Subject: Submittal of Additional Information Concerning Remediation Activities at the
Westinghouse, Waltz Mill Site, Madison, Pennsylvania
License No., SNM-770, Docket No. 07000698

**Response to NRC Letter Dated August 10, 2001
Request for Additional Information
Concerning Remediation Activities**

**Waltz Mill Site
Madison, Pennsylvania**

**Response to NRC Letter Dated August 10, 2001
Westinghouse Electric Company, LLC
Request for Additional Information
Concerning Remediation Activities at the
Westinghouse Waltz Mill Site
Madison, Pennsylvania**

FIGURE A-1
FORMER GROUNDWATER PUMP
AND TREAT SYSTEM LAYOUT
WALTZ MILL SITE
MADISON, PENNSYLVANIA

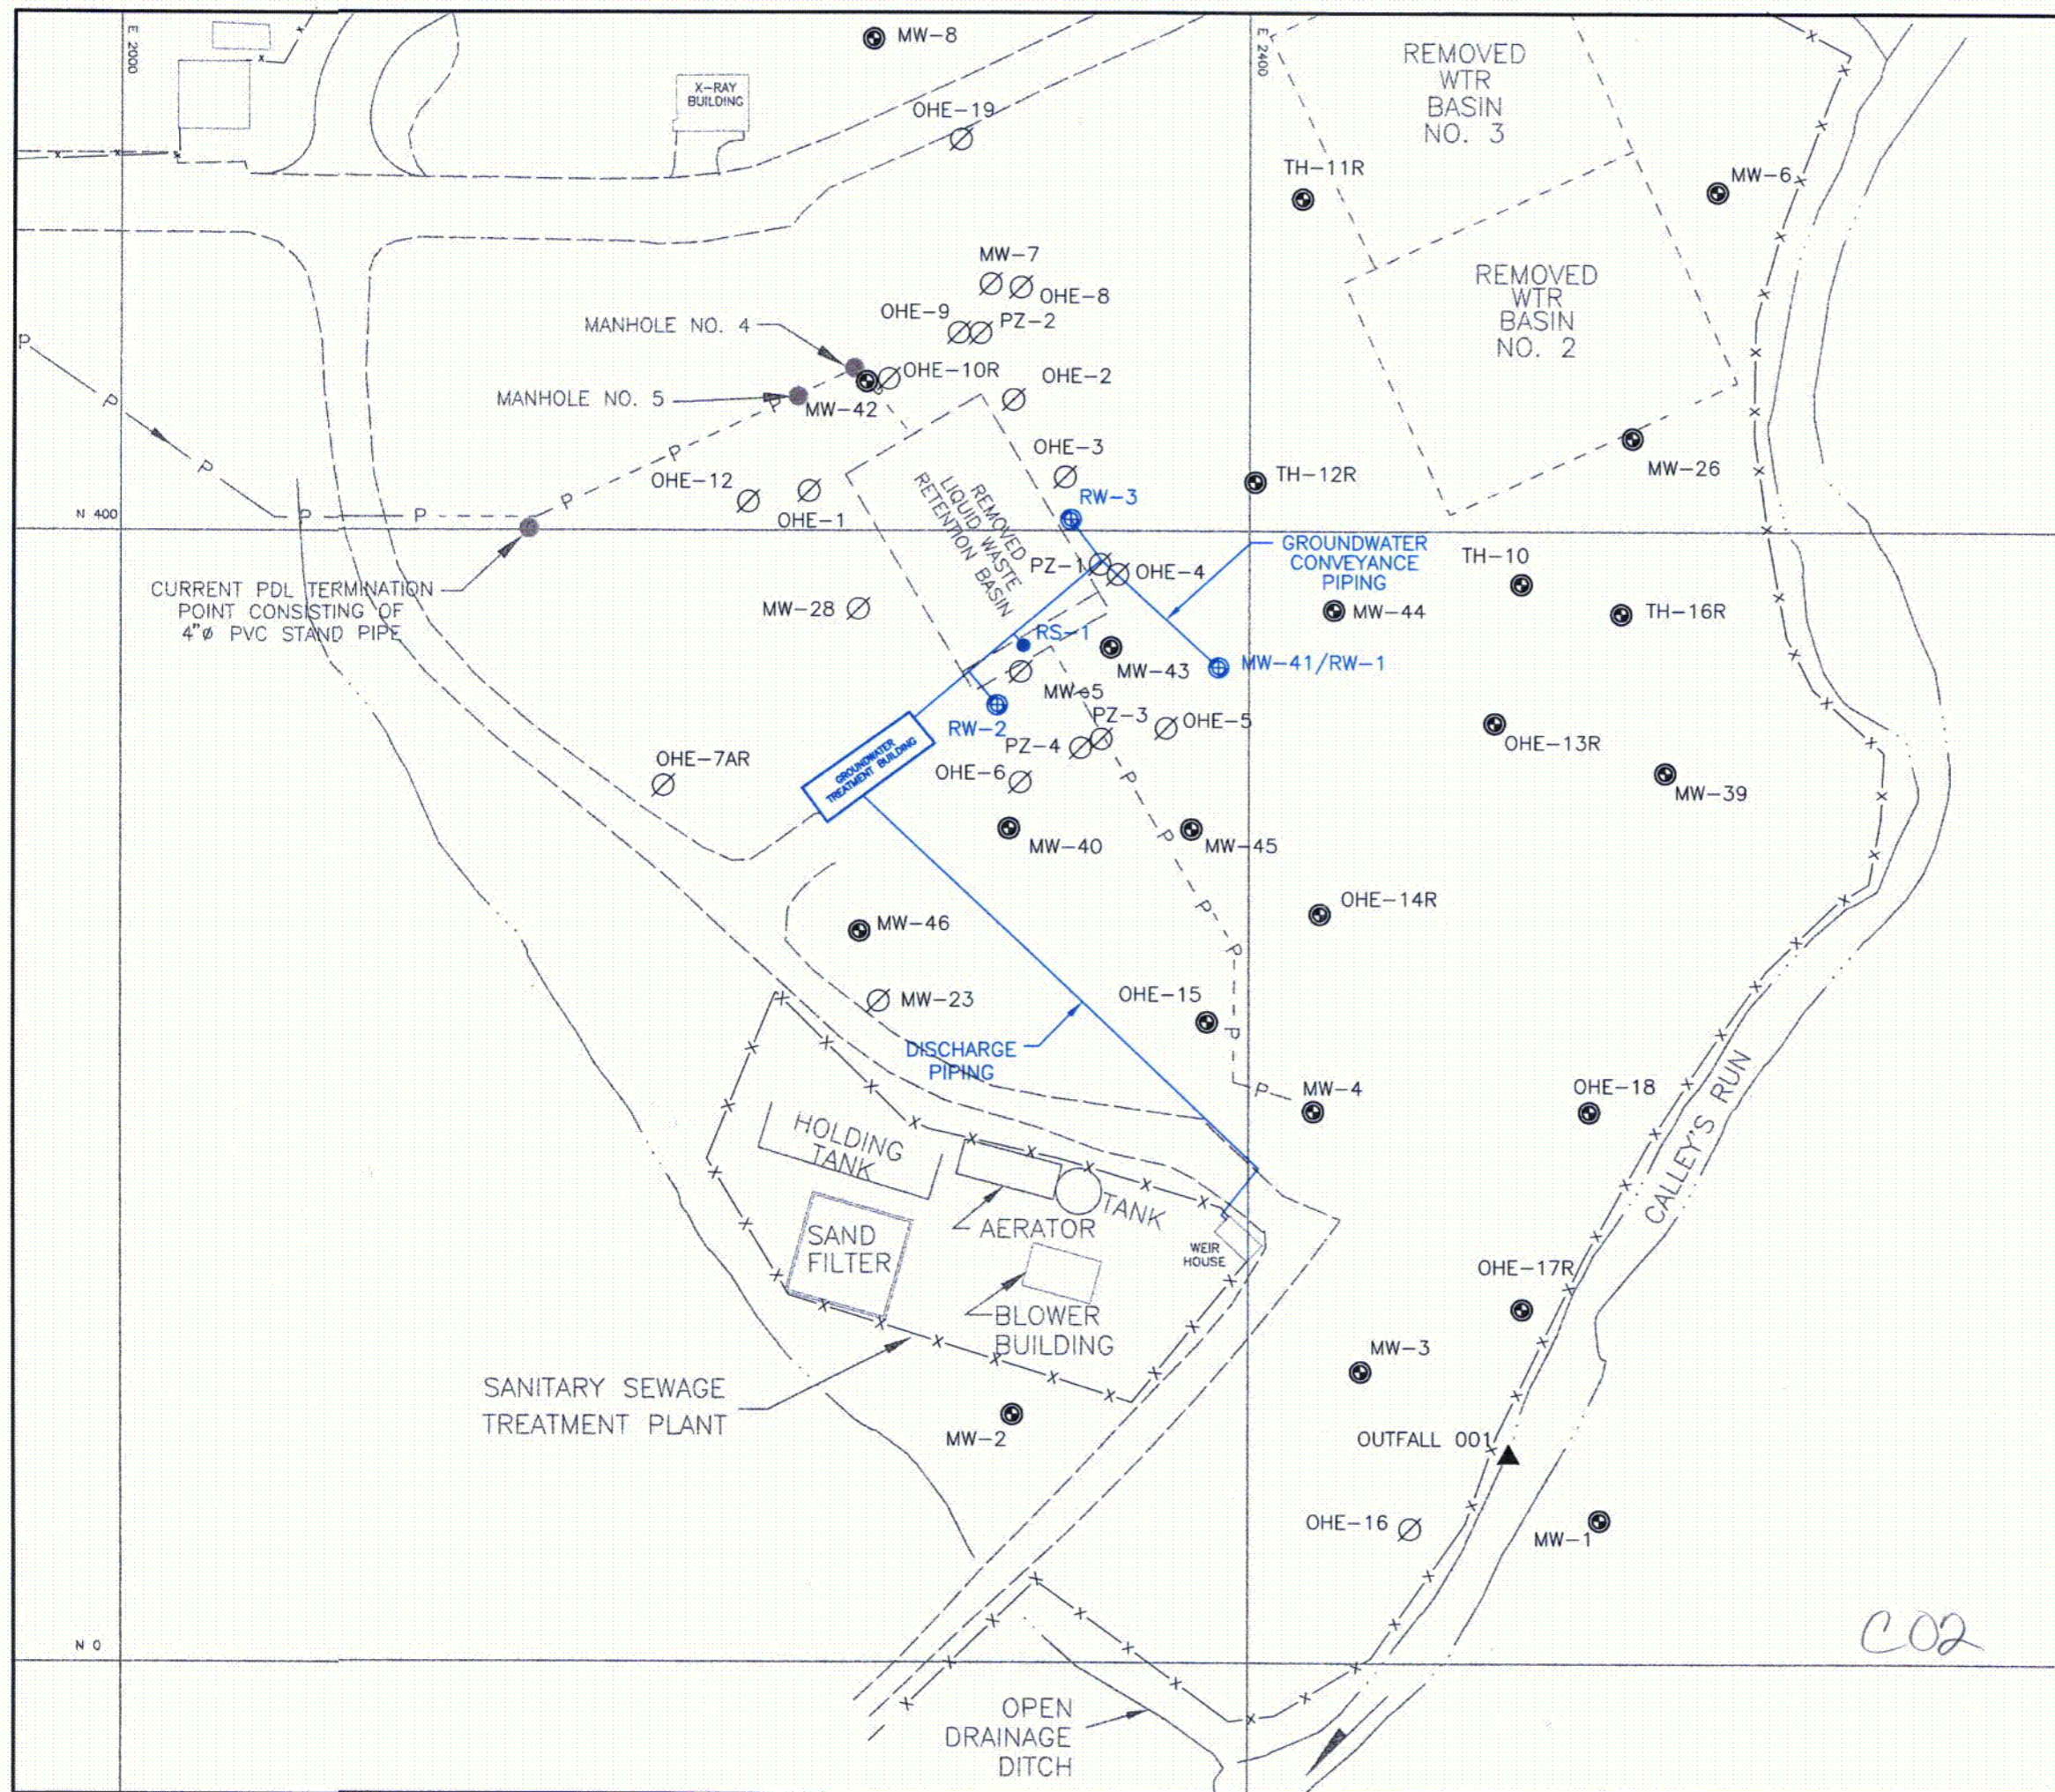
Question No. 4a: The current groundwater pump and treat system has resulted in several measurable groundwater cones of depression; however, there is no verification of containment of the plume. Please provide verification of groundwater containment, such as through particle tracking analysis, as we discussed during our meeting.

The following paragraphs provide a summary of the groundwater remediation system before and following soil remediation activities. Figure A-1 of Attachment A illustrates the groundwater pump-and-treat system that was in place before the implementation of soil remediation activities. The pumping wells consisted of OHE-1 through OHE-4 and MW-5. As outlined in the license amendment dated June 22, 1999, these wells were permanently removed during remediation since they were located in areas of soil contamination requiring excavation. Prior to remediation, two new wells were installed (MW-40 and MW-41) immediately hydraulically downgradient of this area (Figure A-1) for monitoring purposes and potentially as pumping wells, if they were required to contain the plume. To ensure the plume was contained during soil remediation activities, it was decided to use Well MW-41 as a pumping well during soil remediation activities.

Figure B-1

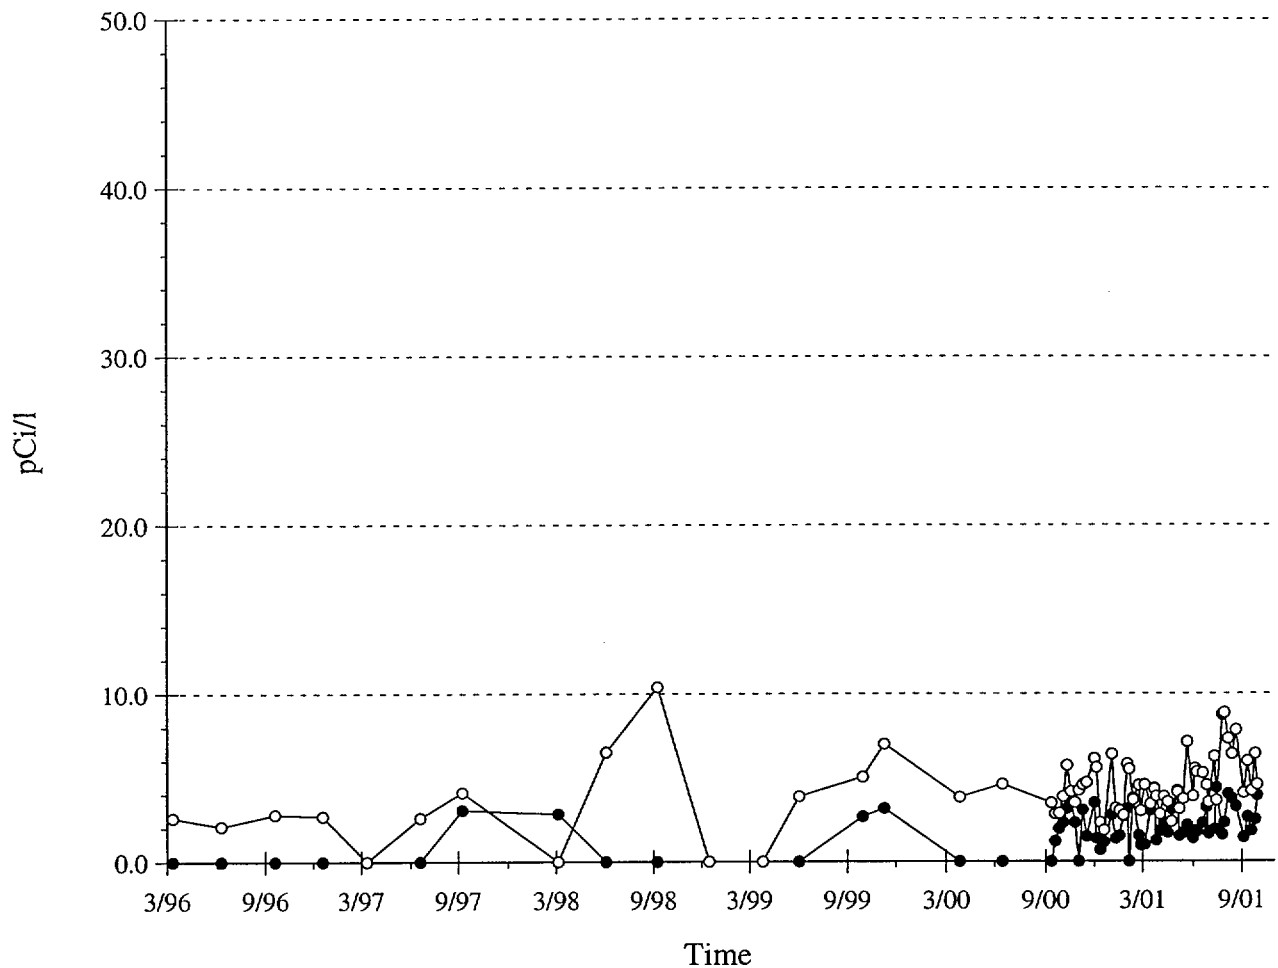
Question No. 4c: In order to evaluate radiochemical data trends for your onsite monitoring wells, please provide radiochemical data obtained since 1999. If possible, please provide the most current map of the groundwater plume configuration, compared to plume configurations measured in the past. Also, please explain the rise in the Sr-90 concentration in Well MW-5 during 1999 from 330 to 575 pCi/liter.

Historical data for Well MW-5 are presented in Attachment B. These data indicate that Sr-90 concentrations have fluctuated over time and that an increase in Sr-90 was observed on several sampling events. Well MW-5 was a remediation well. Because of low-flow conditions, the well was pumped periodically on a timer system. The reason for the fluctuation in concentration and, specifically, the rise in Sr-90 in 1999 could not be determined from the available data reviewed.

FIGURE D-2
GEOLOGIC CROSS SECTION C-C'

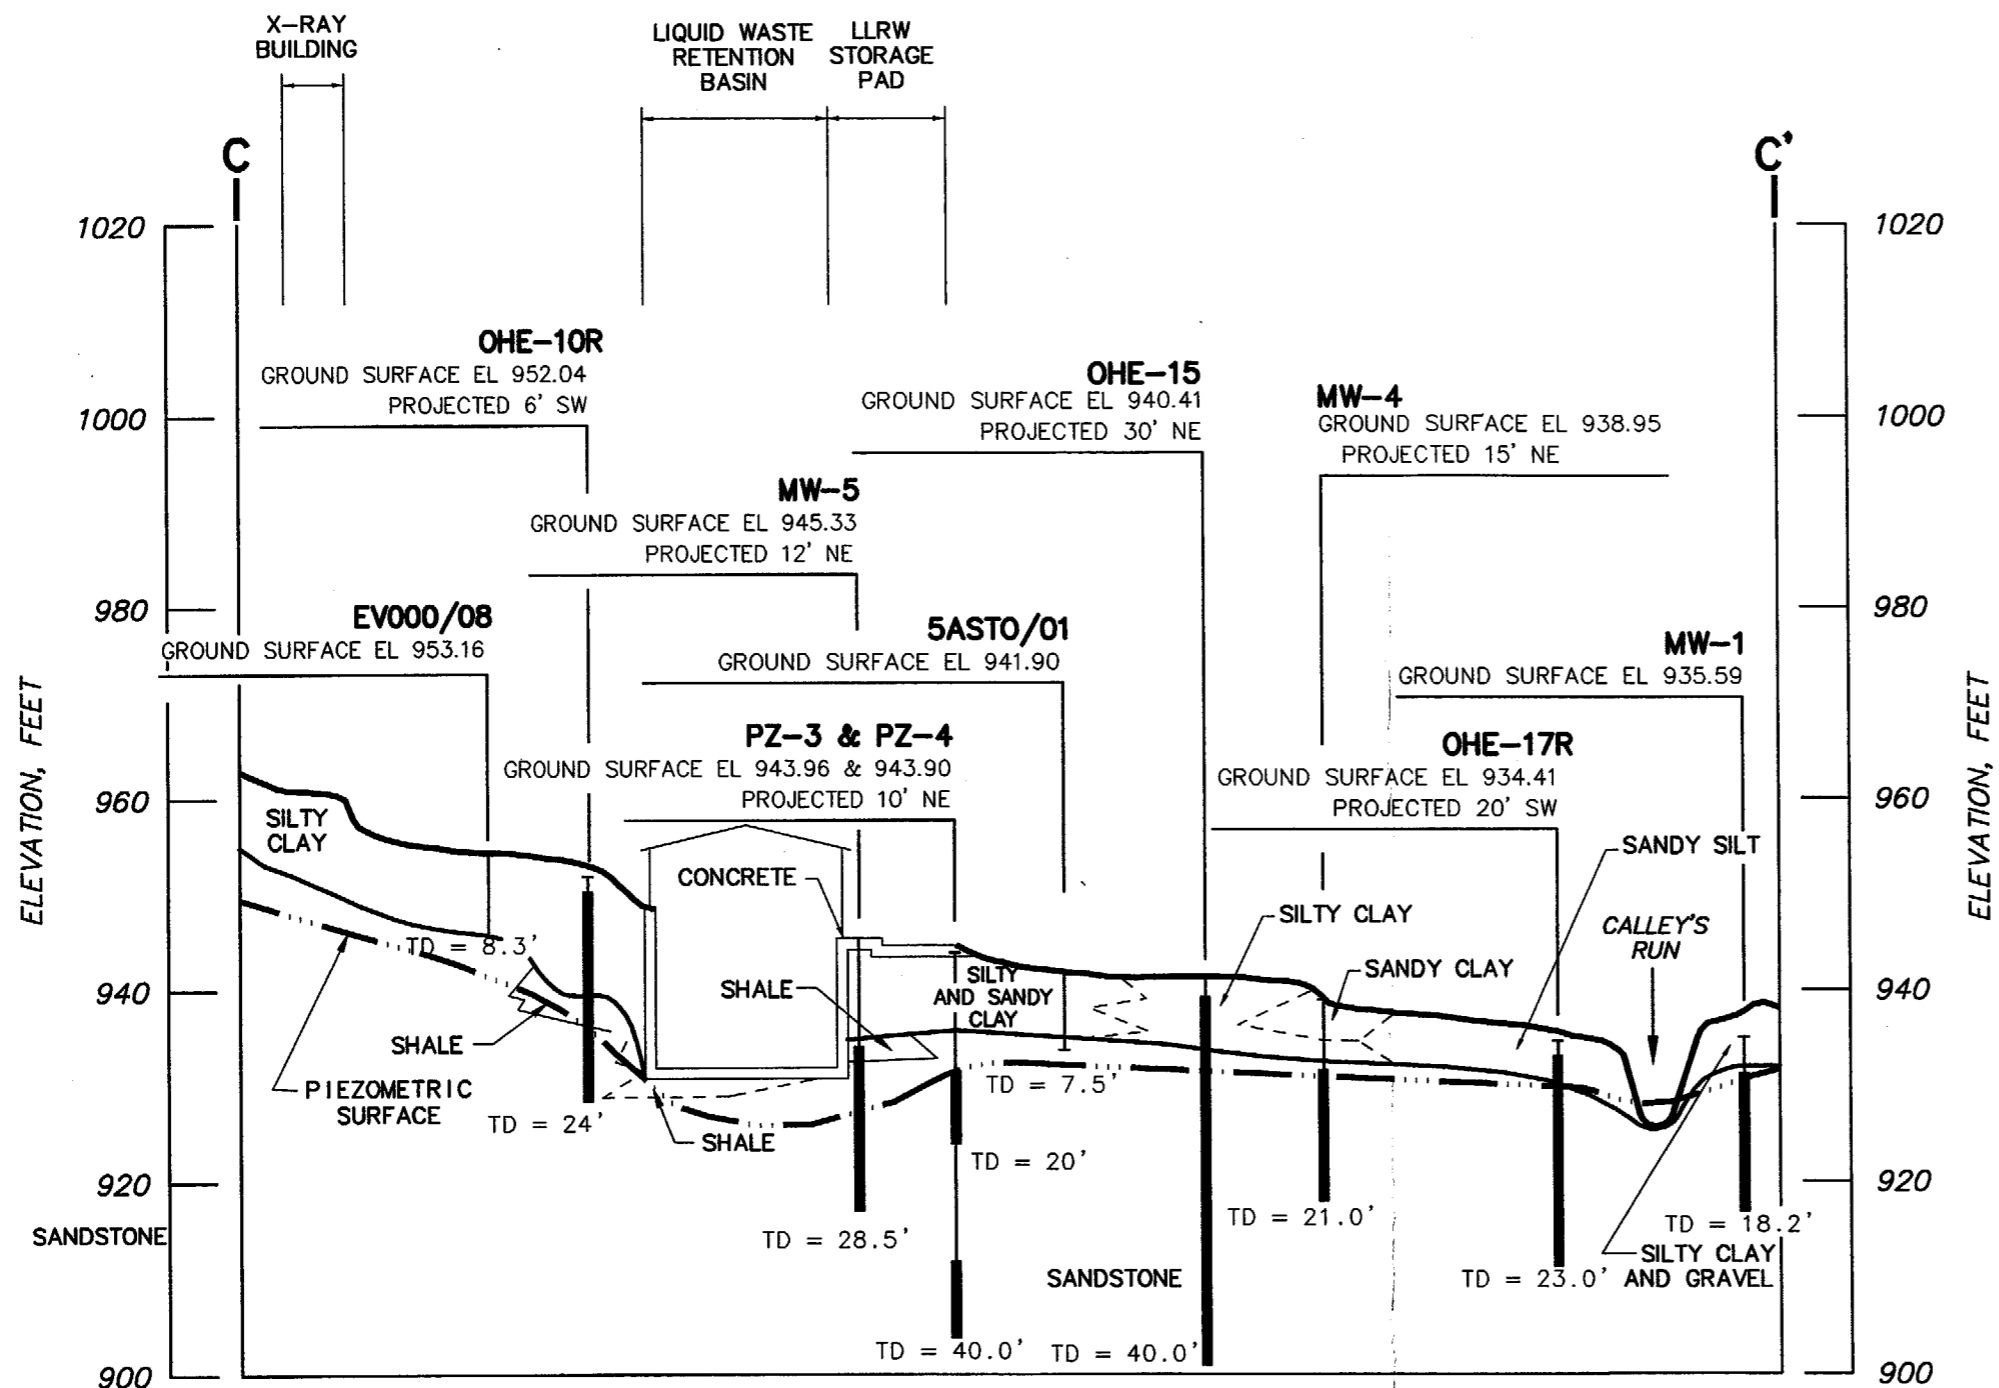
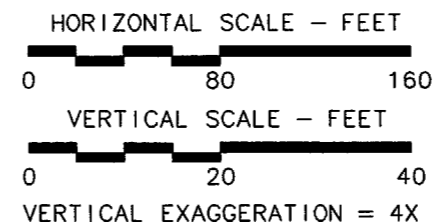
Question No. 7: Does your characterization of groundwater flow confirm that Calley's Run is the local discharge area for onsite groundwater flowing through the contaminated area west of Calley's

Run? What is the impact to offsite dose receptors from the groundwater pathway if contaminated groundwater flows under Calley's Run to an offsite receptor east of Calley's Run.

Response: Geologic Cross Section C-C' (Figure D-2) depicts subsurface conditions beneath and adjacent to Calley's Run. The stream bottom along this section is at an elevation of approximately 928.5 feet above mean sea level. The water depth within the stream can change relatively rapidly following precipitation events. However, based on observations during the soil remediation activities, typical water depth of the stream was observed to be less than 2 feet in wetter times of the year and in drier times of the year the water depth can decrease to several inches.

Historical groundwater elevations were reviewed for Wells OHE-17R, MW-1, and MW-3 and are summarized in Table F-1 (Attachment F). Based on the approximate depth of Calley's Run and assumed minimum/maximum stream water depths, these data indicate that the groundwater elevations in these two wells are higher-than-anticipated seasonal stream surface elevations. Based on these data, Calley's Run can be considered a local groundwater discharge zone for the uppermost water-bearing zone. This information is consistent with conclusions made by CNWRA in their technical report. In Section 3.2, Paragraph 2, CNWRA notes, "Migration of the contaminant plume to the southeast, the direction of groundwater flow, is limited by Calley's Run, a nearby stream that runs along the eastern boundary of the site. Surface water in Calley's Run is fed by local groundwater."

As a groundwater discharge zone, groundwater to some depth below the stream would discharge into the stream. However, at greater depths, some flow may continue beneath the stream toward the MW-1 area. Well MW-1 was installed historically to evaluate this potential pathway and groundwater results indicate it has not been impacted. Therefore, it can be concluded from this information, in conjunction with the data presented in the response to Question No. 5 (vertical depth of contamination), that Calley's Run does provide a hydraulic barrier to groundwater contaminant migration. Furthermore, groundwater contamination is only minimally reaching monitoring points along the western side of the stream and, therefore, a source of contaminated groundwater does not exist that could move off site east of Calley's Run.
